SCHOLARSTOWN HOUSE

FURTHER INFORMATION RESPONSE

APRIL 2023

South Dublin County Council Reg.Ref. **SD22A/0401**

1.1 Amended Plans to reinstate original windows to rear return

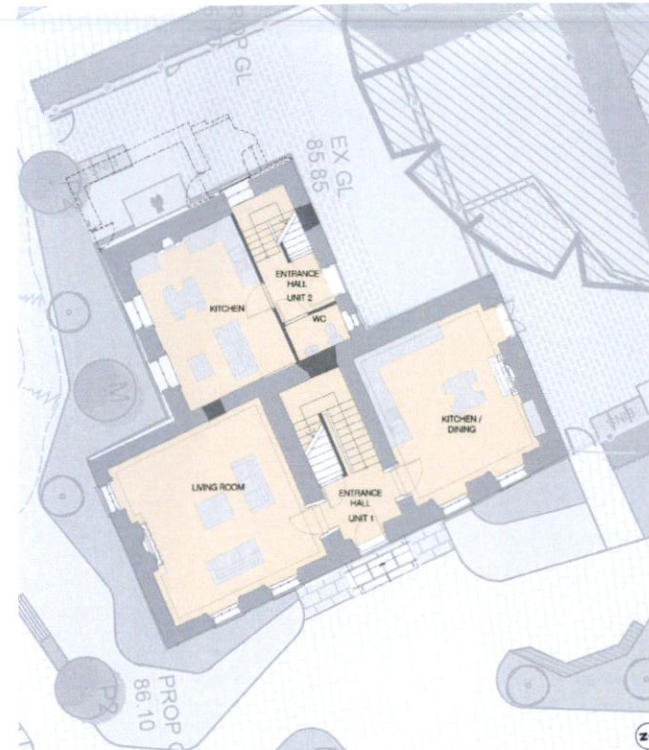
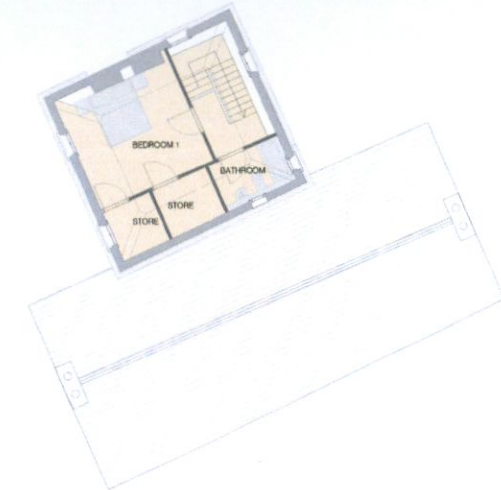
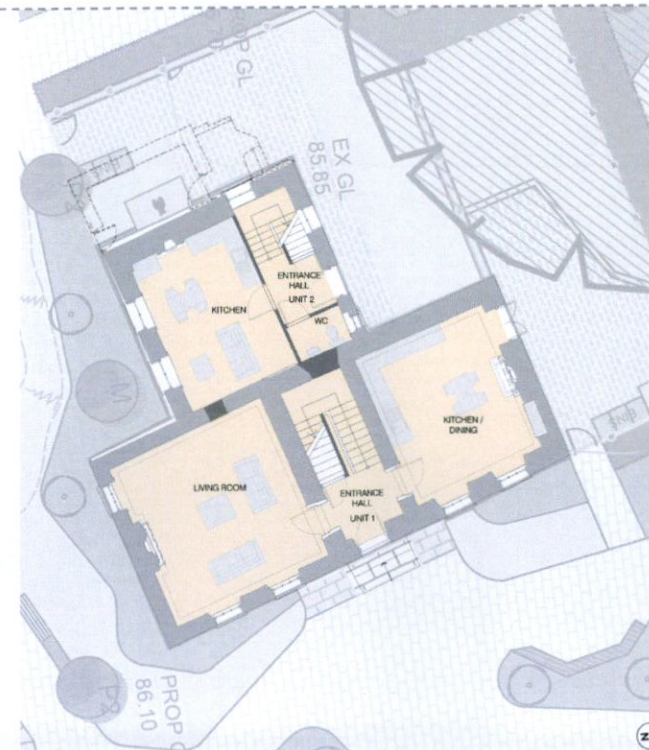
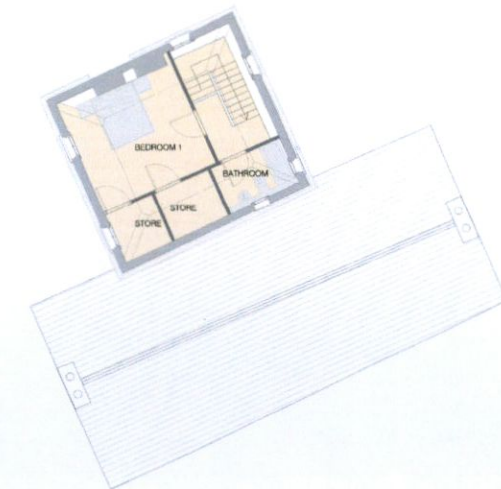
- *It is considered that where original windows are proposed to be blocked up alternatives should be considered, or alternative designs considered in order to provide a solution and the retention.*

- *Removal of original architectural features is not acceptable and where this has been indicated, mitigation measures or alternative floor plans should be provided in order to negate the removal of architectural features.*

As per the RFI request, the original window position on the rear return have now been retained in their original position.

In the application as submitted, it was proposed that these windows were to be blocked up in addition to other amendments in order to facilitate the new stairs to serve the proposed unit.

The amended scheme works with the existing window openings with glass balustrades introduced as safety mechanisms to separate the users from the windows while providing the benefit of the visual aesthetic and additional day light penetration into the internal space. This maintains the existing external facade fenestration and is considered to overcome the concerns of the Council in this regard.

1.2 Design Response

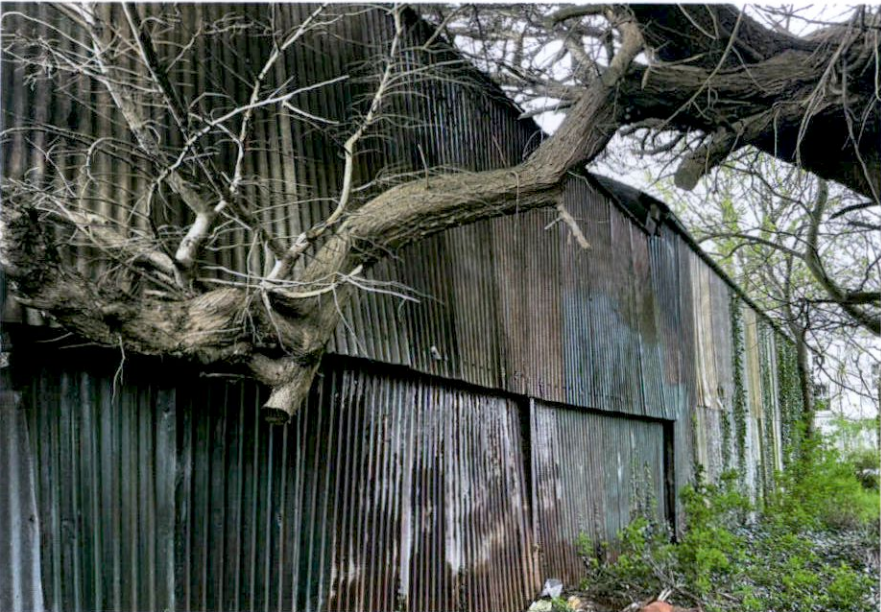
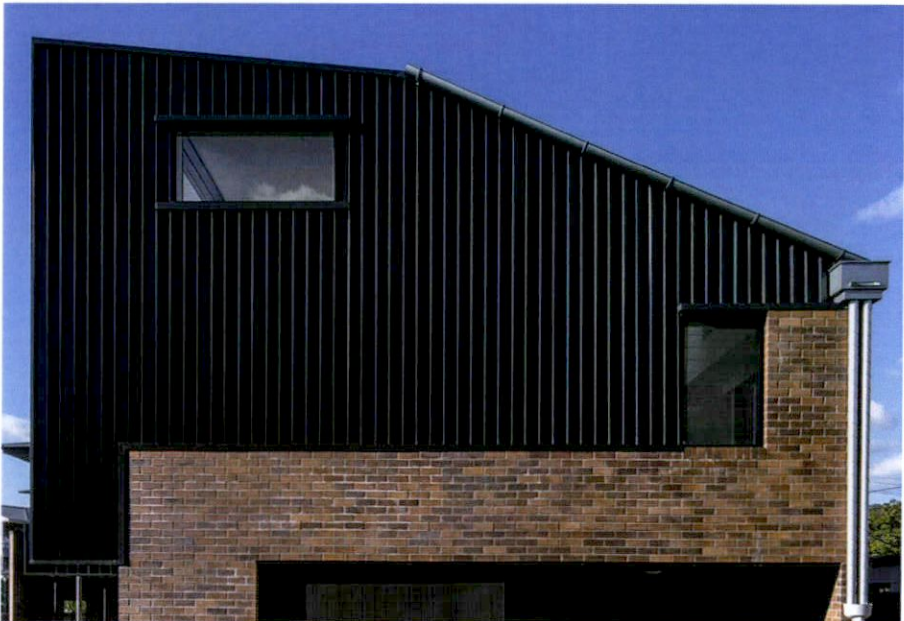
(e) As previously advised during pre-planning discussions the block form needs to be broken up in different heights and different treatments with some separation between to provide separate block forms. The outbuildings should be considered with regard to adaptive reuse and reflecting the outbuildings in the design ethos of one or two blocks or using the original footprint to provide additional new building where the existing corrugated shed is located. The elevational treatment and materiality should reflect a more rural and agricultural style of building type that would connect visually to the existing protected structure and provide high quality design and character to the site.

Please refer to accompanying response prepared by Conservation Consultant John Cronin in conjunction with the following proposed amendments to scheme design in response to the above item.

-Alternative façade material (metal cladding) to recessed element which visually breaks up the building massing when viewed from north east (please refer to 3D View – North East in the attached)

The overall strategy for the amendments an reduction to the overall building massing is outlined in Chapter 02. Furthermore the scheme is considered carefully to respond to the characteristics of the setting of each of the block forms. In addition to the modulation of the block forms and facade articulation which creates the opportunity to create high quality façades but also offers the opportunity for material changes.

The use of variety of material finish to different facade elements offers the visual connection from new and old. The corrugated iron cladding of the old agricultural buildings reinterpreted into the façades of the new building creating a resonance with the past.

The recess of the block form to the junction of the three storey block and the four storey block in combination with a change of facade material creates a visual break offering the view of separate block forms. The location of this recess and materiality change also aligns with the front elevation of the existing Scholarstown house offering a pleasing alignment and respect of the existing house central within the composition.

Proximity To South West Boundary

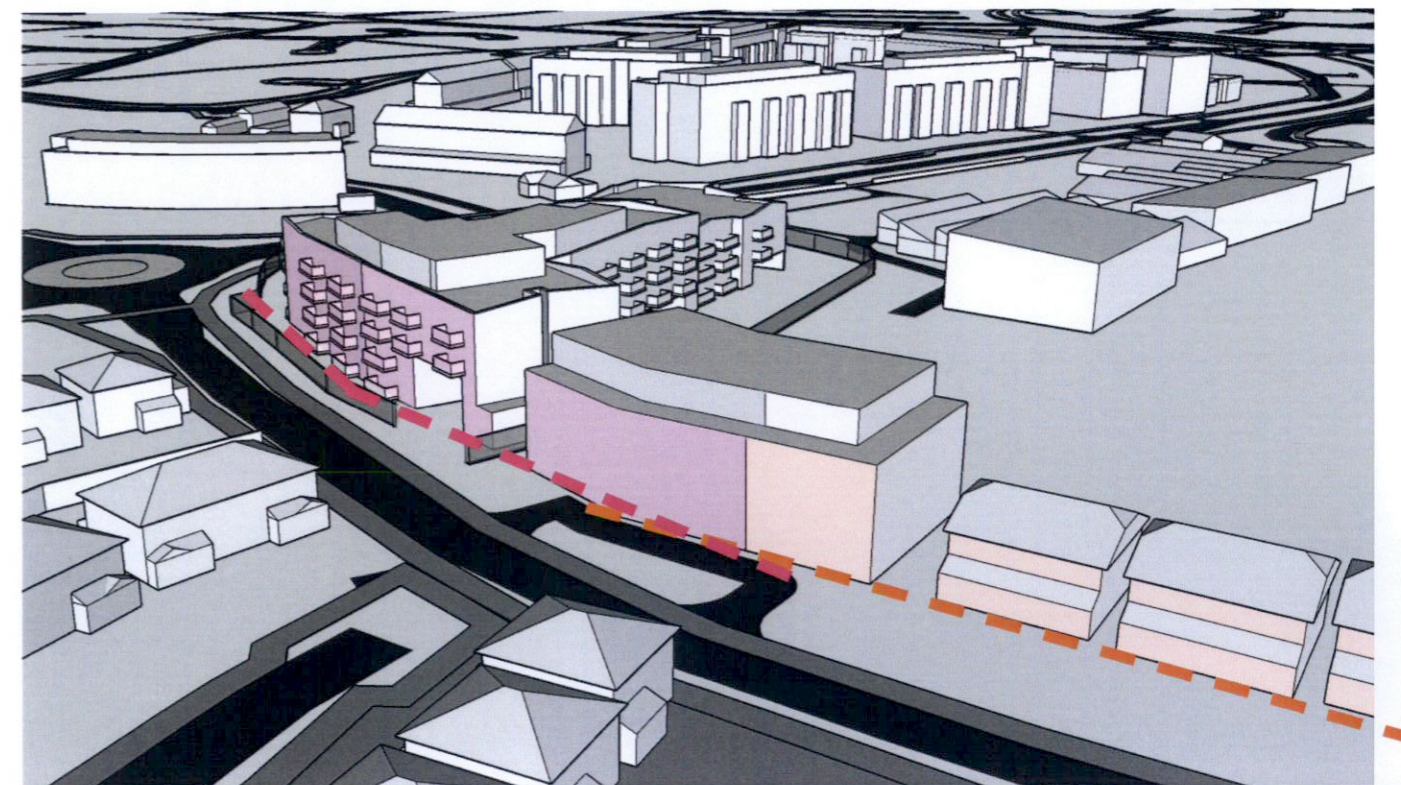
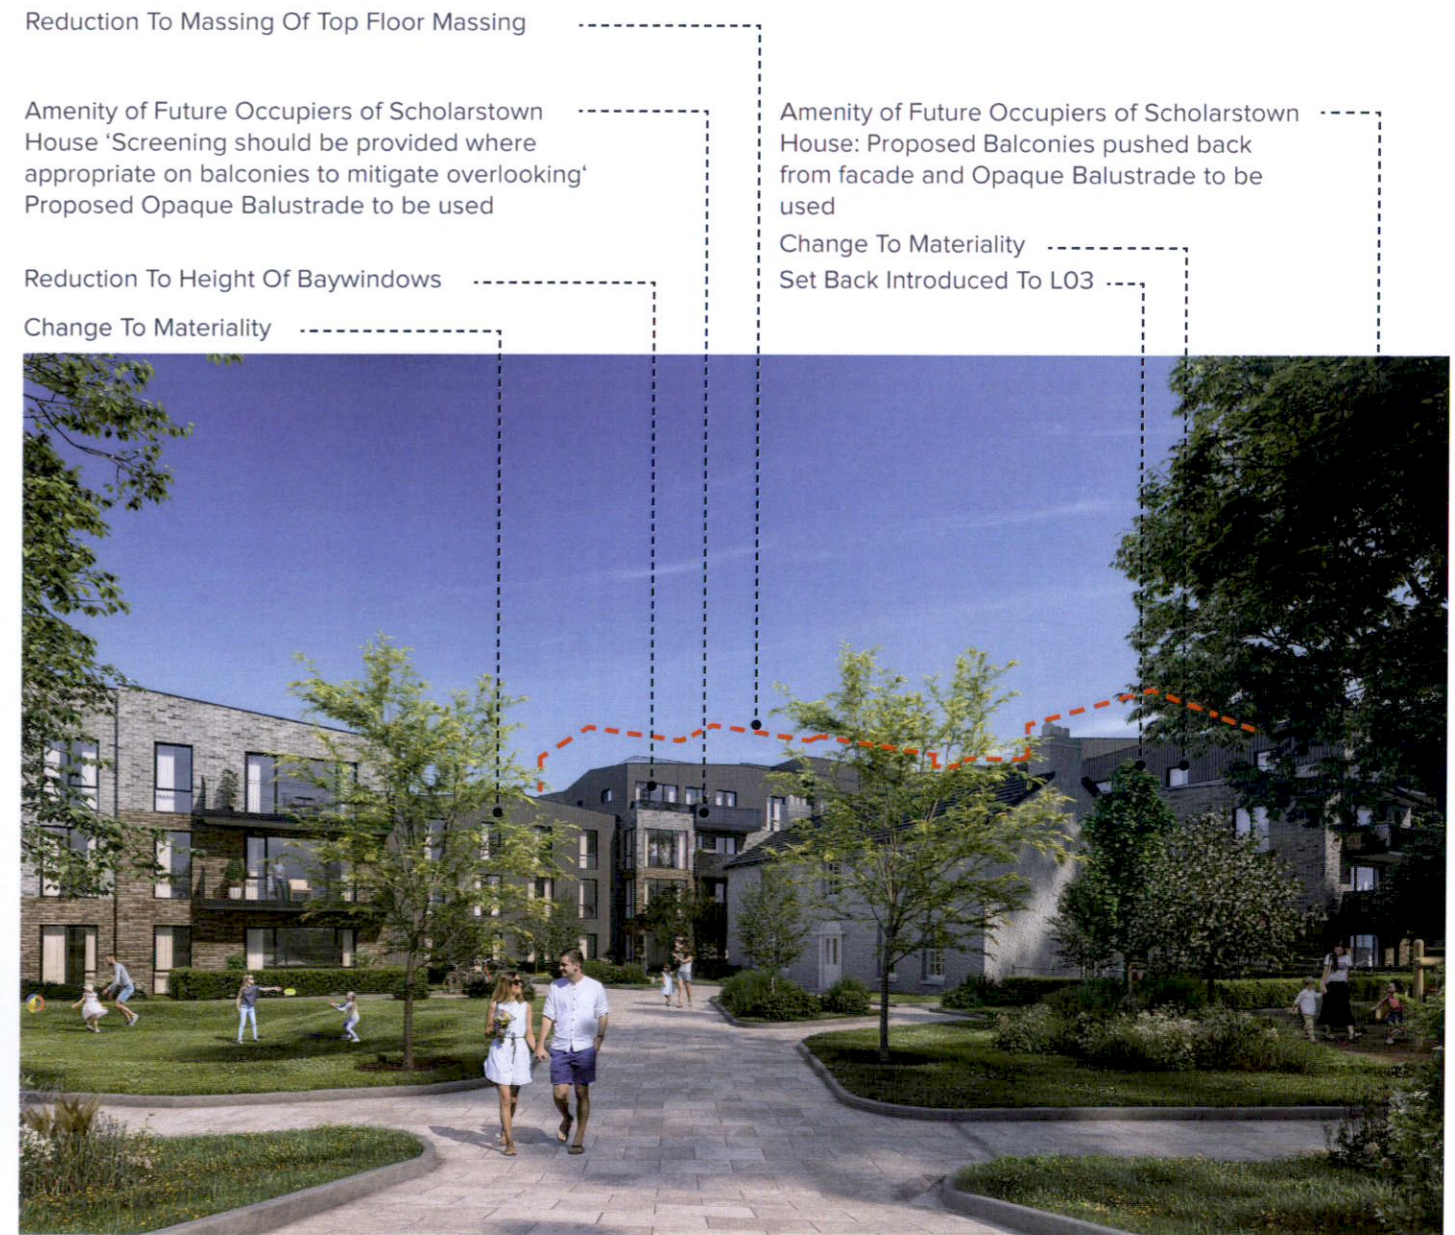
(a) The approach to height should be reconsidered in relation to impact on the Protected Structure and residential amenity. The Planning Authority would have concerns about where within the site, taller elements are proposed. The four storey element would be less than 1m from the south-western boundary, adjoining RES zoned lands. Windows to habitable rooms would be in close proximity to this boundary. The applicant is requested to submit a revised design at this boundary, including providing an increased separation distance of the higher elements of the building from this boundary and improved boundary treatment, to help mitigate any overbearing impact.

The separation distance to the south western boundary has been increased to min4m on L02 and L03 of the scheme. The 'step' within the building form combined with the inset brick detail and the opaque windows offers further articulation to this elevation. The windows within this elevation may be removed however it is believed that the additional dual aspect light is a benefit to the internal of the respective units while not having any negative impacts on adjoining lands.

The potential future development of the south-western boundary RES zoned lands would most probably be designed to respond to create a new urban edge onto Orlagh Grove road. This new urban edge could potentially follow a similar strategy in terms of the existing uses on the site or new residential units with own door access which would activate the street frontage.

Please refer to adjoining sketch masterplan 'Potential Future Condition' illustration and 3D massing which illustrates how the adjoining site could be potentially developed in the future and the application Scholarstown House scheme provides a strong response to both the current condition of the two storey with pitched roof buildings and the potential future new building forms. The proposed development will not have an impact on the future potential of the lands to the south.

L04: FOURTH FLOOR LEVEL

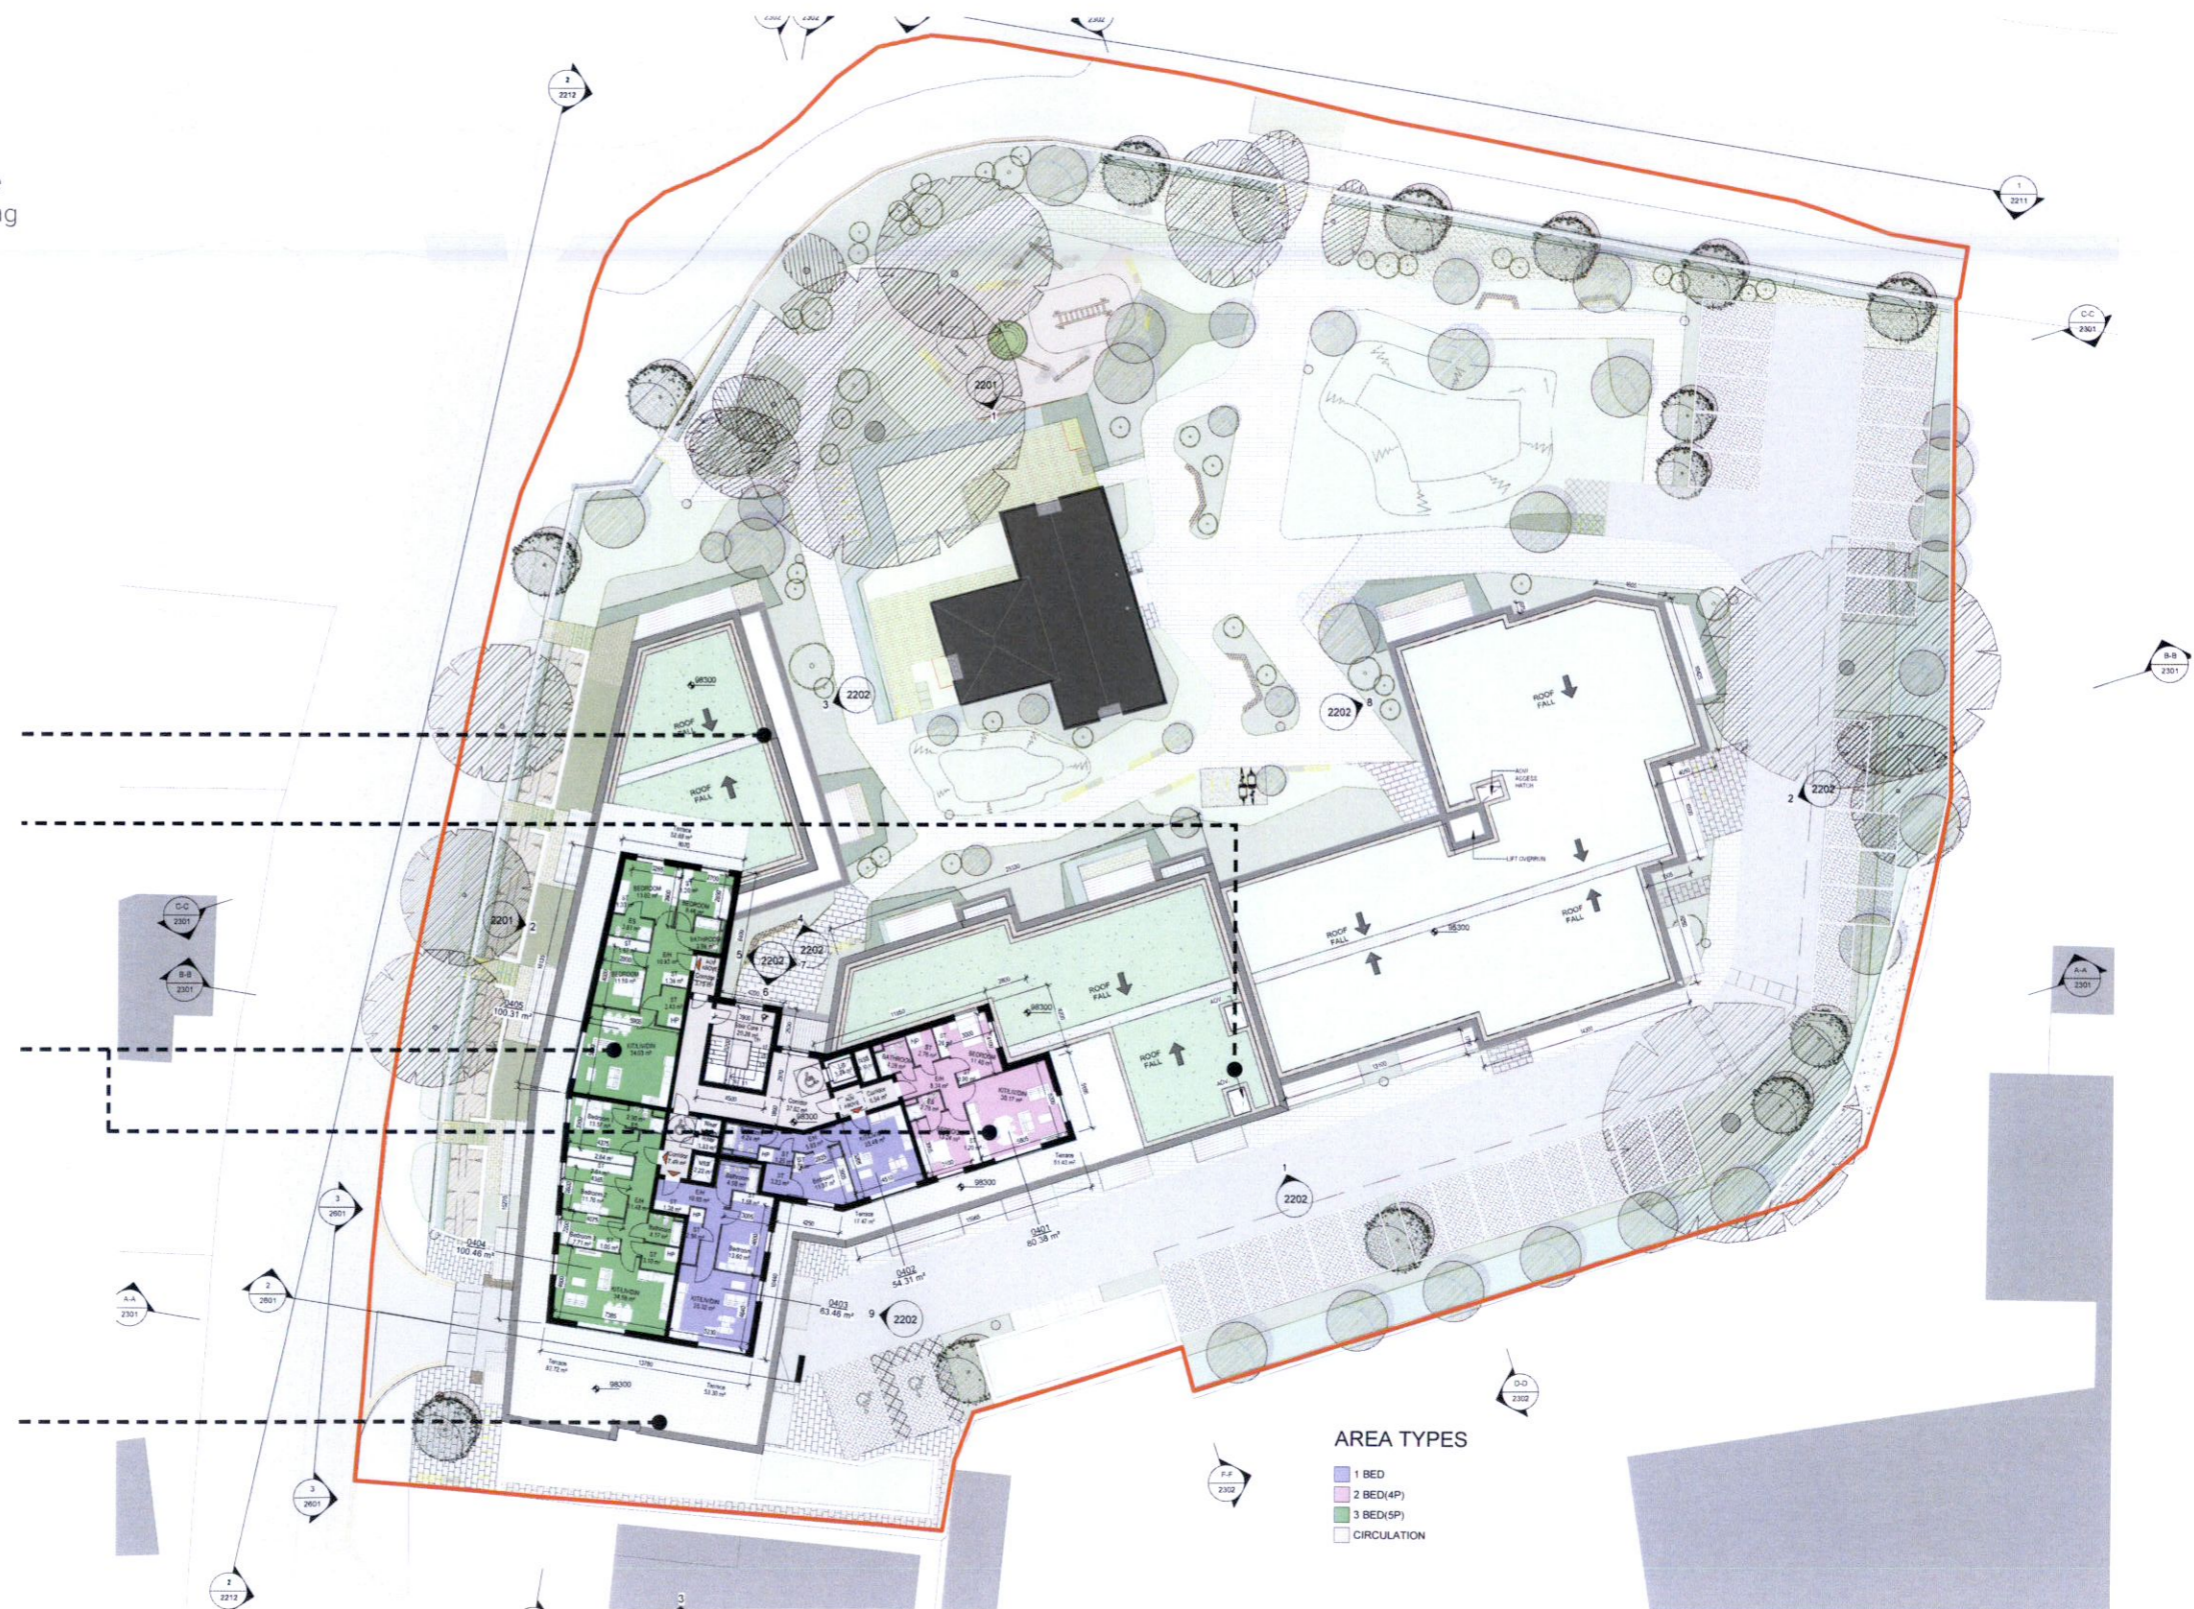
(c) *Although separation has been provided in providing limited but designed setting to the Protected Structure, it is considered that by virtue of the height of the proposed apartments the Protected Structure is completely overshadowed. The mass and scale of the apartment block which completely surround the Protected Structure to the rear as a backdrop and to the side, is overbearing and causes negative visual impacts. In order to less the visual impact the overall height, scale and mass of the 5-storey element needs to be reduced and overall design revised.*

(d) *It is considered that the overall design, mass and height should be reconsidered and revised in order to find a greater balance between the existing and new development. It is noted that the height has been reduced where the new block forms a backdrop to the protected structure, however, not enough has been done in relation to the overall design to the adjoining block to provide a building type that doesn't completely overshadow and dominate the entire site.*

- Reduction To Extent of Fifth Floor Set Back Level To 3no Units Adjacent To Primary Core
- Staircore has been omitted to reduce massing

Setback (1.8m) Length Of Apartment below

Staircore Omitted To This Level

Reduction To Extent of Fifth Floor Set Back Level To 5 no Units Adjacent To Primary Core

Separation Distance Increased

Dual Aspect Ratio

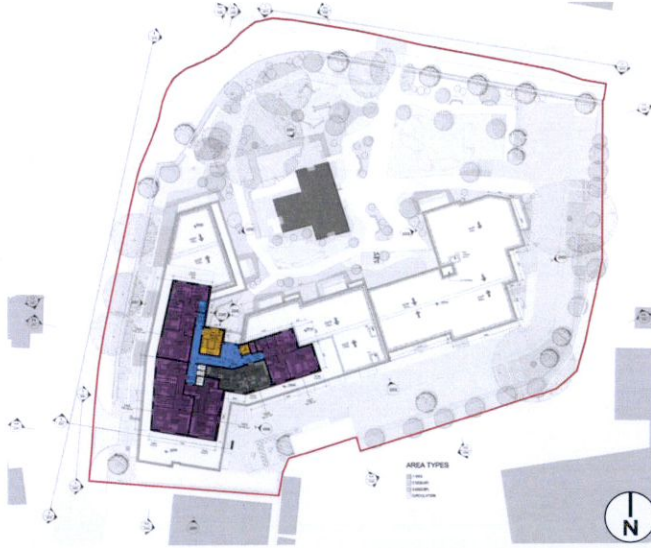
As noted in the Chief Executive's Order Apartment Nos. 0007, 0111, 0215 are considered as single aspect in the dual aspect calculations. The submitted design has provided a total of 38no. Dual Aspect units as outlined in the table. An overall percentage of 53% of the units within the proposed scheme are dual aspect. It is submitted that this is fully compliant with the above policy and is in excess of the 33% and also the 50% requirement stipulated within the policy objectives.

The aspect of all units has been considered carefully to optimise the orientation of the site and sun/day light to apartment units.
